ORIGINATION FORM

Proposed Revisions to a Standard Plans Index
(Please provide all information — Incomplete forms will be returned)

Index Number: 654-001
Sheet Number (s): 1 of 1
Index Title: Rectangular Rapid Flashing Beacon Assembly

LAST REVISION	11/01/21	DESCRIPTION:		FY 2021-22 STANDARD PLANS	RECTANGULAR RAPID FLASHING BEACON ASSEMBLY	INDEX 654-001	SHEET 1 of 2
---------------	----------	--------------	--	------------------------------	--	------------------	-----------------

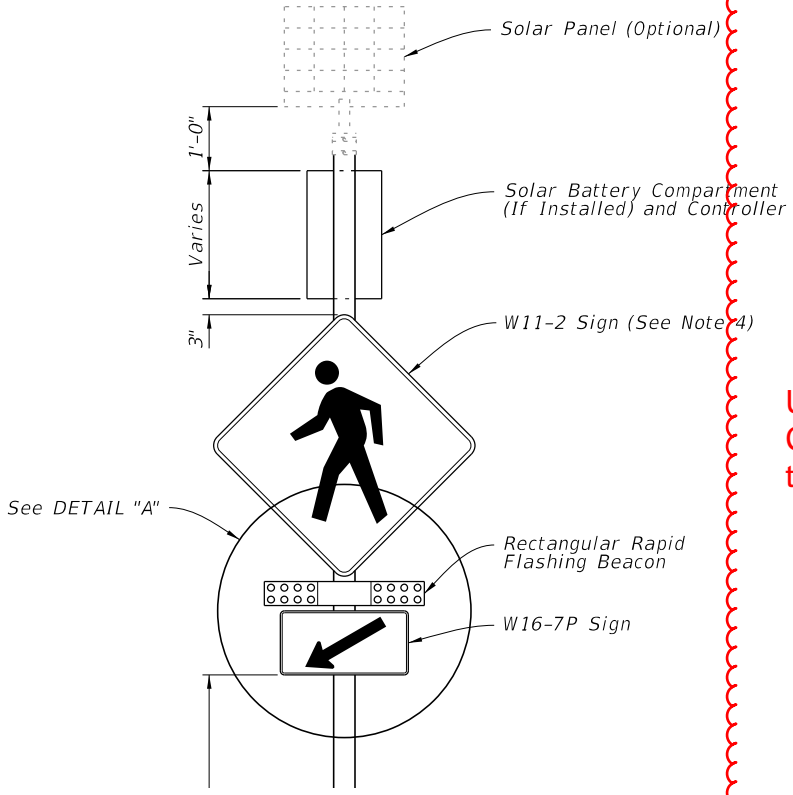
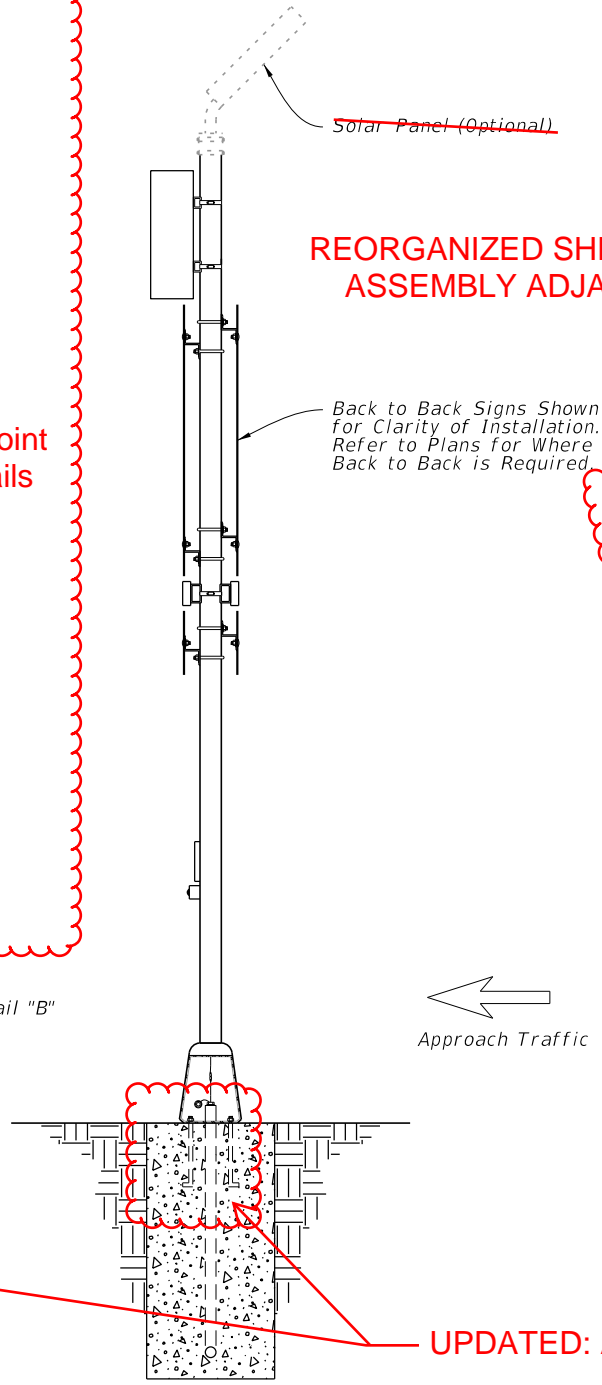
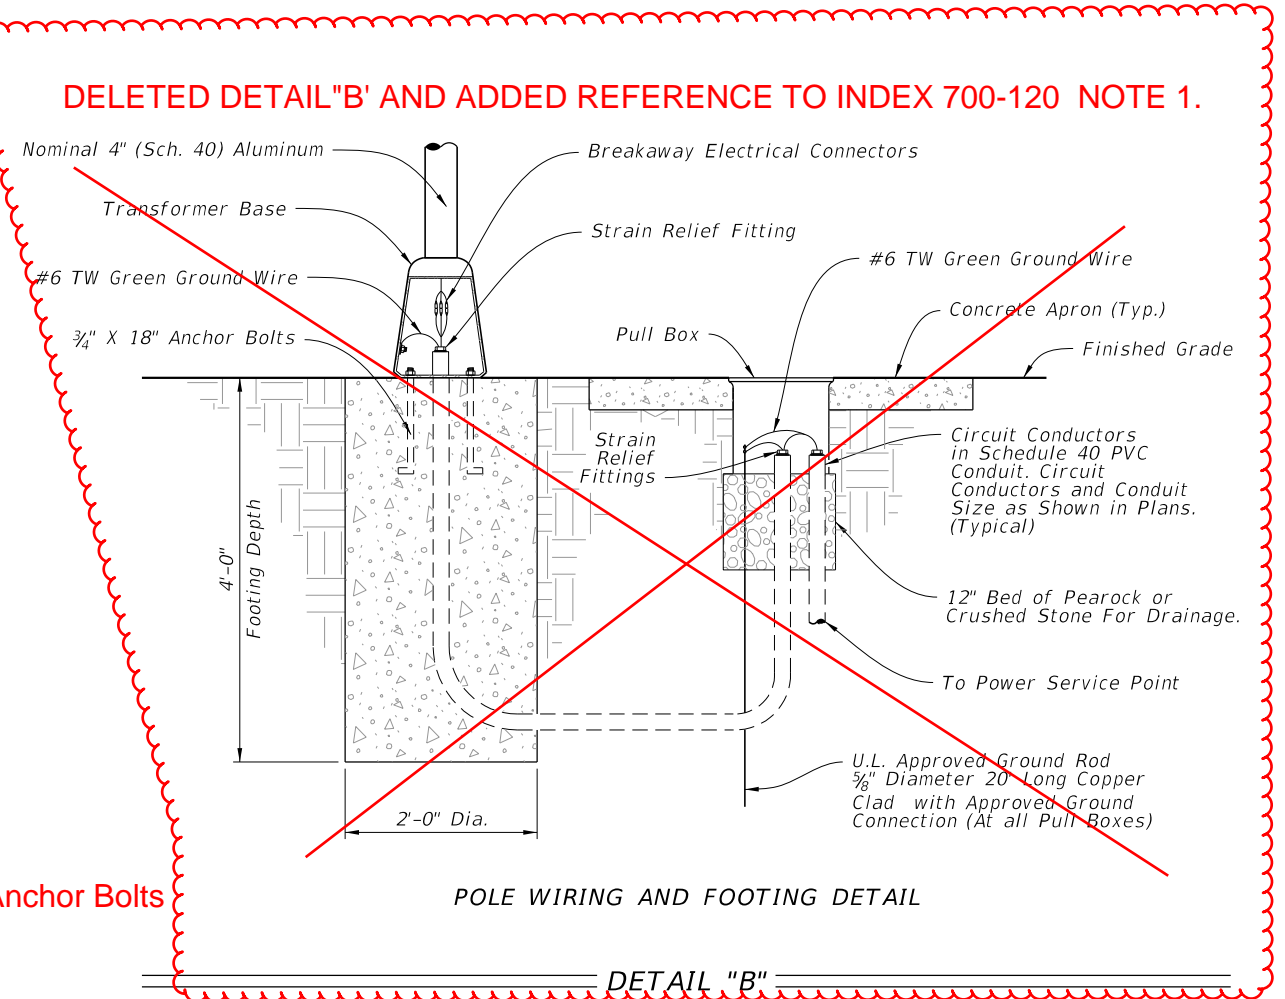
1. A transformer base is required for both conventionally-powered and solar-powered applications (conventional power shown).
2. Install the RRFB in pairs, one on either side of approach traffic.
3. Install controller on the back **CHANGED NOTE 1: to reference Index 700-102**
4. Install a 30" X 30" W11-2 sign 36" X 36" W11-2 sign for mu.
5. Install push button and FTP-68C-21 sign in accordance with Index 665-001.
6. Engage all threads on the transformer base and post unless the aluminum post is fully seated into base.

7. Meet the requirements of Specification 646 for ~~aluminum poles and transformer bases.~~ **CHANGED NOTE 4**
8. Install a concrete slab around all pull boxes. The minimum slab dimension is 4'-0" by 4'-0". In urban areas where space is limited slab dimensions may be adjusted as shown in the Plans.
9. For assemblies connected to conventional power, provide single pole non-fused watertight breakaway electrical connectors in the frangible transformer base.
10. When wire entry holes are drilled in the sign column, use a bushing or rubber grommet to protect conductors.
11. For solar-powered applications, orient solar panel to face South for optimal exposure to sunlight.

REORGANIZED SHEET TO SHOW BEACON ASSEMBLY ADJACENT TO SIDEWALK

UPDATED: Callout to point to both details

DELETED DETAIL "B" AND ADDED REFERENCE TO INDEX 700-120 NOTE 1.

UPDATED: Anchor Bolts

CHANGED TO: Nominal 4" Aluminum Pole (Sch. 40) (4.5" OD)

LAST REVISION 11/01/21	DESCRIPTION:	 FY 2022-23 STANDARD PLANS	RECTANGULAR RAPID FLASHING BEACON ASSEMBLY	INDEX 654-001	SHEET 1 of 2
---------------------------	--------------	--	---	-------------------------	------------------------

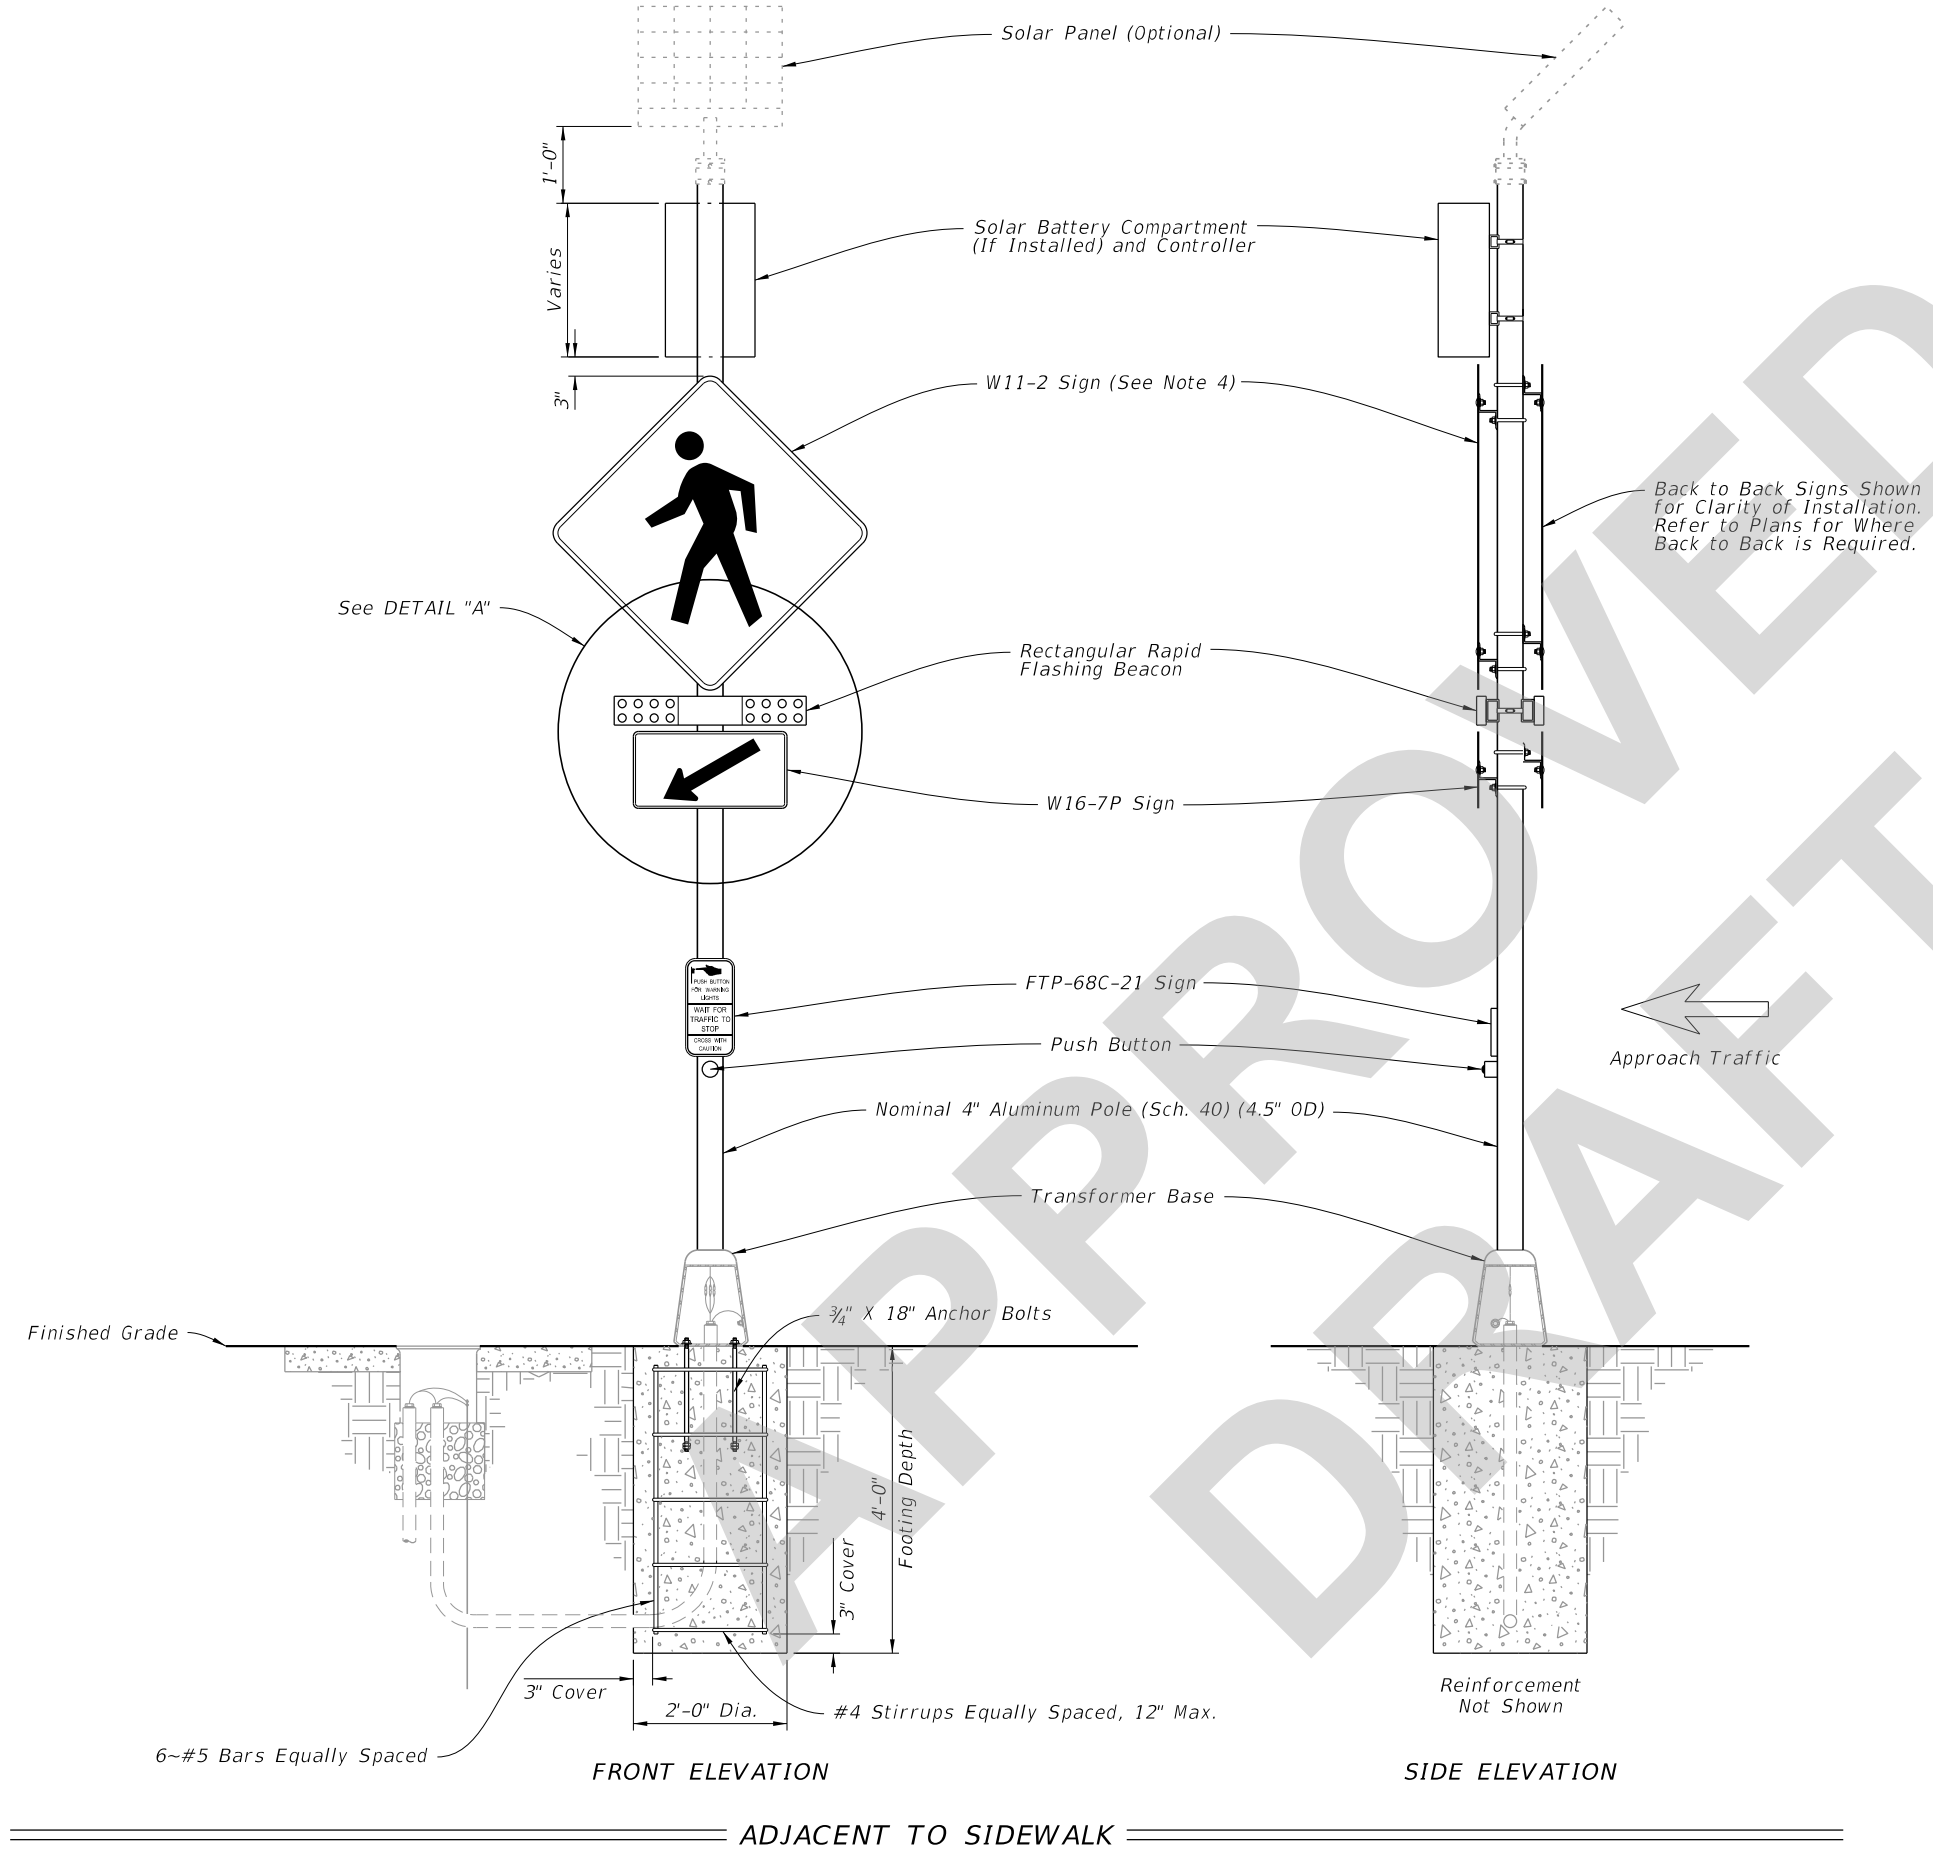
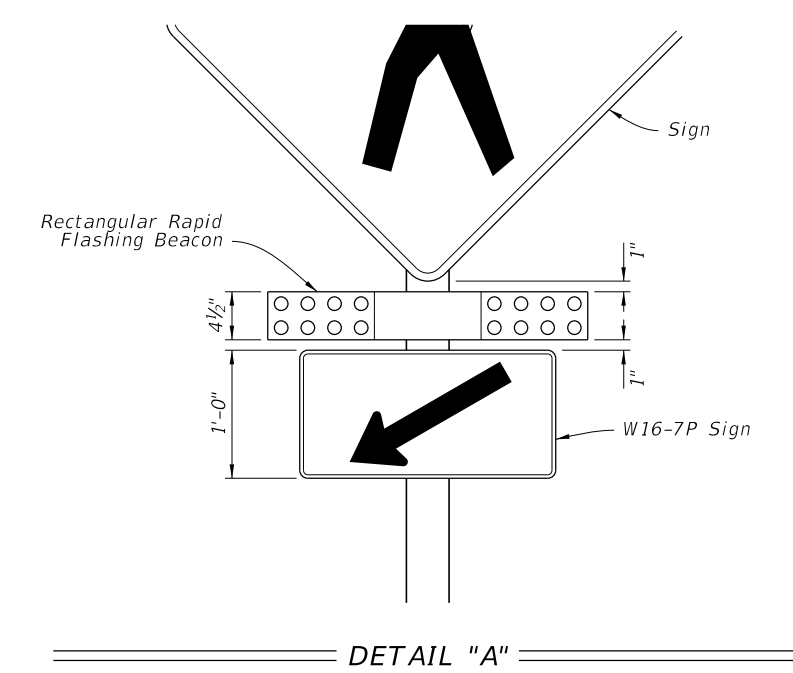
NEW SHEET

SHOWING BEACON ASSEMBLY IN SIDEWALK CURB

LAST REVISION 11/01/21	REVISION	DESCRIPTION:	 FY 2022-23 STANDARD PLANS	RECTANGULAR RAPID FLASHING BEACON ASSEMBLY	INDEX 654-001	SHEET 2 of 2
---------------------------	----------	--------------	--	--	------------------	-----------------

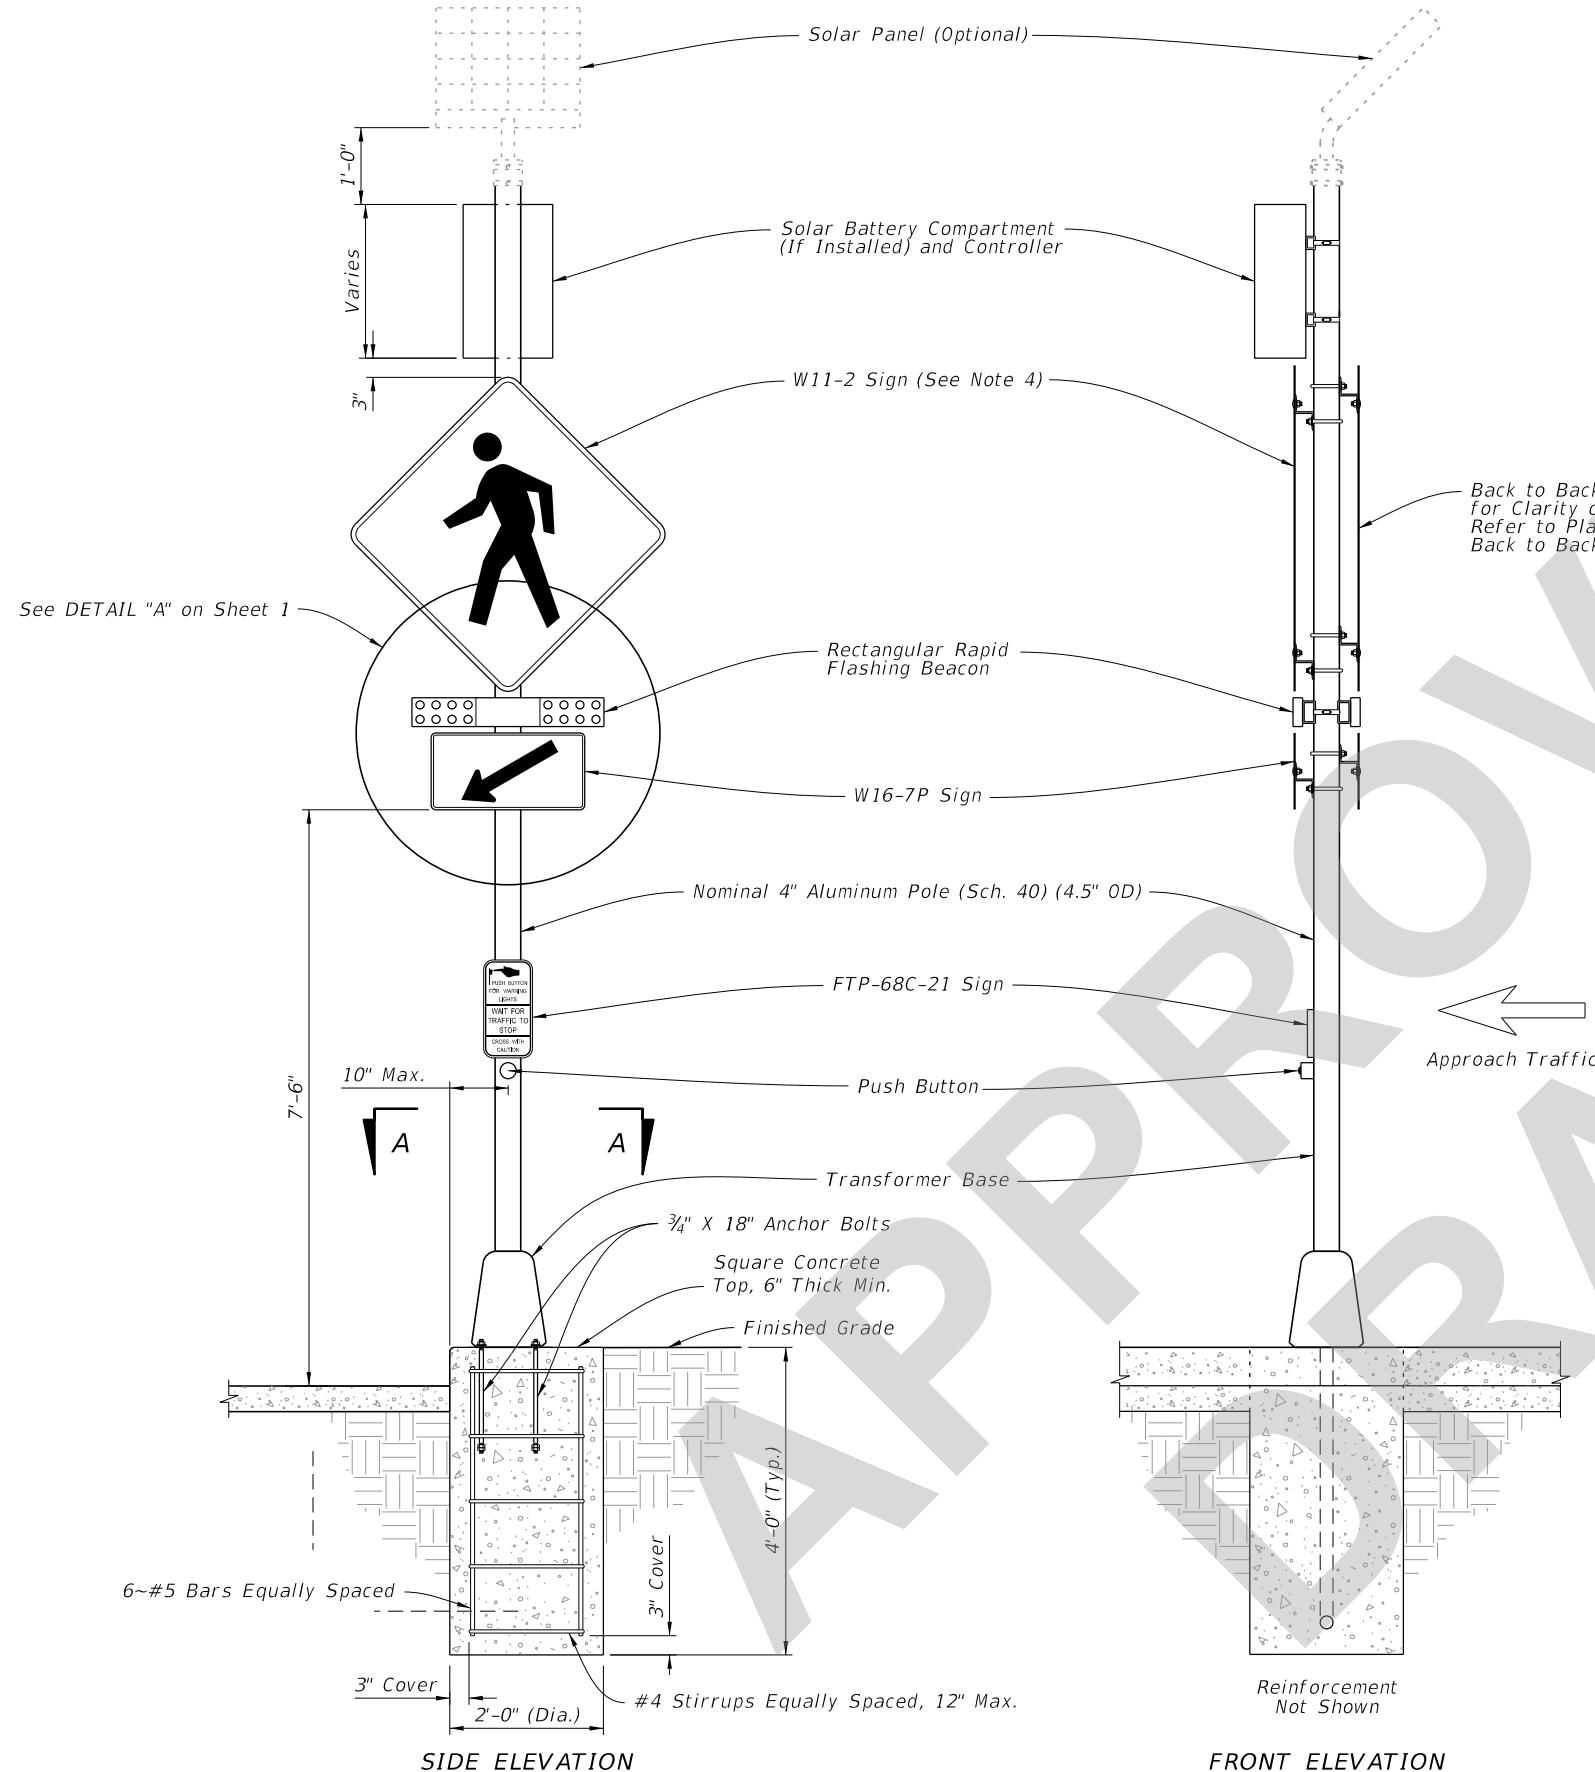
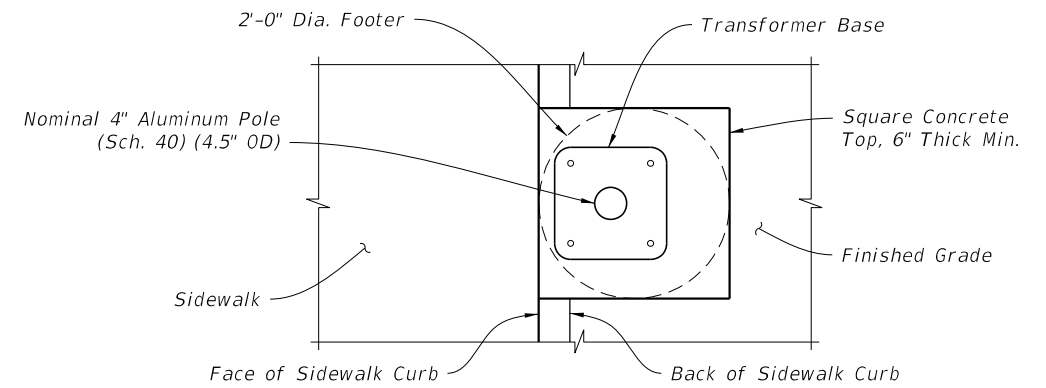
Sheet 2: (New Sheet) showing the Beacon Assembly in the Sidewalk Curb.
